AP1000 DESIGN CERTIFICATION REVIEW

Response to Request For Additional Information

RAI Number: 220.007

**Figure 3.8.3-7
IRWST Temperature Transient**

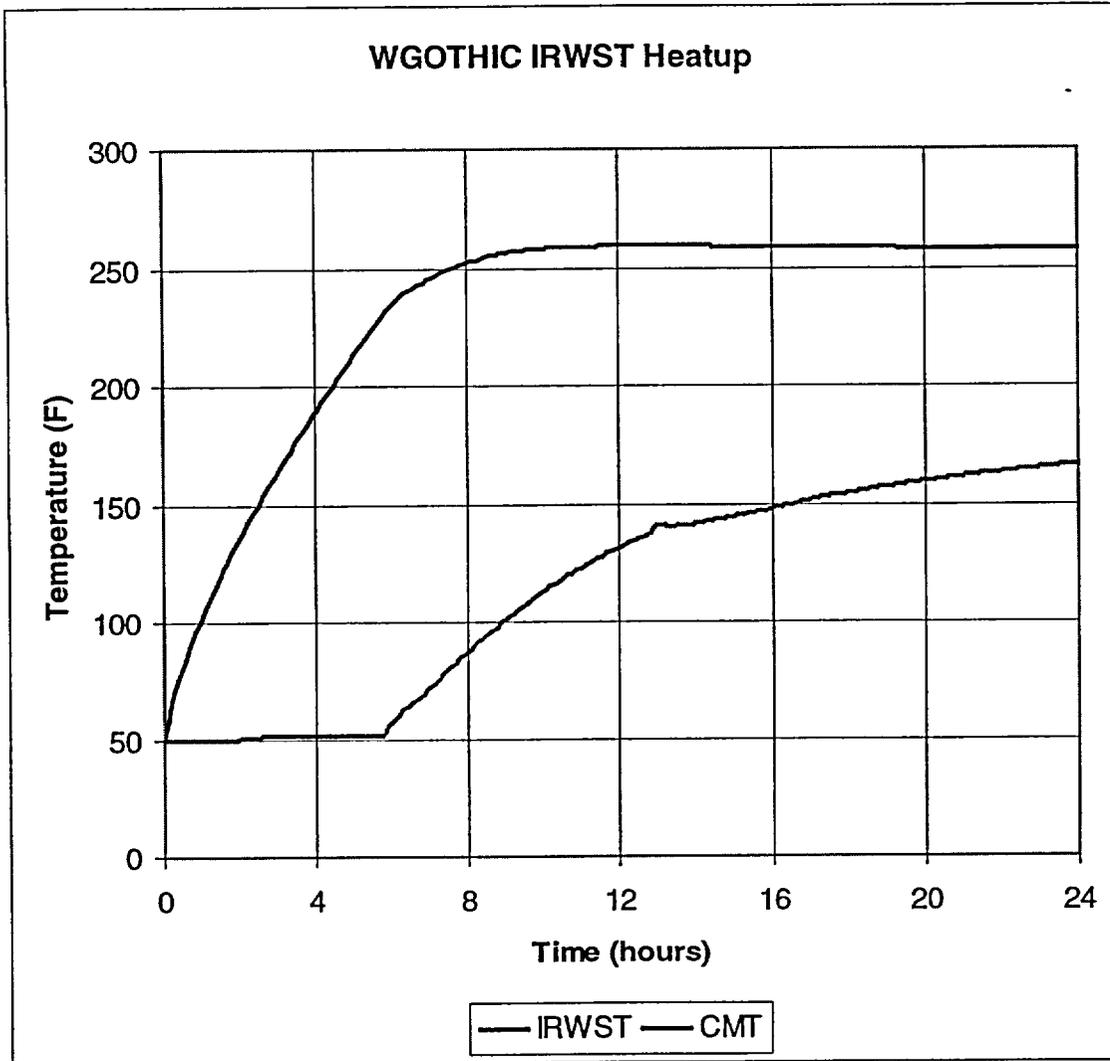
AP1000 DCD Subsection 3.8.3.3.1, "Passive Core Cooling System Loads," describes the pressure and thermal transients associated with operation of the passive core cooling system which are used to evaluate structures inside containment. Some of the water temperature transients have changed from the AP600 design and it is not clear how these have affected the analysis and design of the structural modules. Therefore, please address the following issues:

- A. The transient temperature was revised from 240°F reached in 5.5 hours (AP600) to 250°F reached in 3.5 hours (AP1000). Provide a discussion to explain the change and how this change was considered in the analysis and design of the AP1000 modules?
- B. The extreme transient starting temperature used for the structural design was revised from 50°F (AP600) to 70°F (AP1000). This would seem to be less extreme than the 50°F case in the AP600 design. Provide the basis for this change and explain how this change was considered in the analysis and design of the AP1000 modules?

The AP1000 containment model was used to determine the IRWST water temperature as a function of time. Decay heat is added to the IRWST using a heater component to represent the PRHR heat exchanger. The following assumptions are used in this model:

- ANSI-79 decay heat with 2σ uncertainty
- IRWST water volume = 75,300 ft³
- IRWST initial temperature = 50°F
- Complete mixing in the IRWST (no stratification)
- No heatup of IRWST walls or other structures (all decay heat deposited in IRWST)
- Full reactor power of 3400 MWt prior to simultaneous scram and PRHR actuation.
- Containment pressure conditions as calculated by WGOthic.

The IRWST temperature transient is shown in the attached Figure 3.8.3-7, which will be added in the DCD. The IRWST begins steaming approximately 5 hours after the event is initiated, and reaches a maximum temperature of 259°F in approximately 11 hours. The containment atmosphere heats up once the IRWST steams. This transient will be used to determine the thermal loads on the IRWST walls. There are no changes in the analysis or design criteria for

Revise second bullet in subsection 3.8.3.3.1:

- **ADS₂** – This automatic depressurization system transient considers heatup of the water in the in-containment refueling water storage tank. This may be due to prolonged operation of the passive residual heat removal heat exchanger or due to an automatic depressurization system discharge. **For structural design an extreme transient is defined starting at 50°F since this maximizes the temperature gradient across the concrete filled structural module walls.** Prolonged operation of the passive residual heat removal heat exchanger raises the water temperature from an ambient temperature of 42050°F to saturation in about 2-5 hours, increasing to about 2560°F within about 113.5 hours. Steaming to the containment atmosphere initiates once the water reaches its saturation temperature. The temperature transient is shown in Figure 19.E.4.10-43.8.3-7. Blowdown of the primary system through the spargers may occur during this transient and occurs prior to 24 hours after the initiation of the event. Since the flow through the sparger cannot fully condense in the saturated conditions, the pressure increases in the in-containment refueling water storage tank and steam is vented through the in-containment refueling water storage tank roof. The in-containment refueling water storage tank is designed for an equivalent static internal pressure of 5 psi in addition to the hydrostatic pressure occurring at any time up to 24 hours after the initiation of the event.
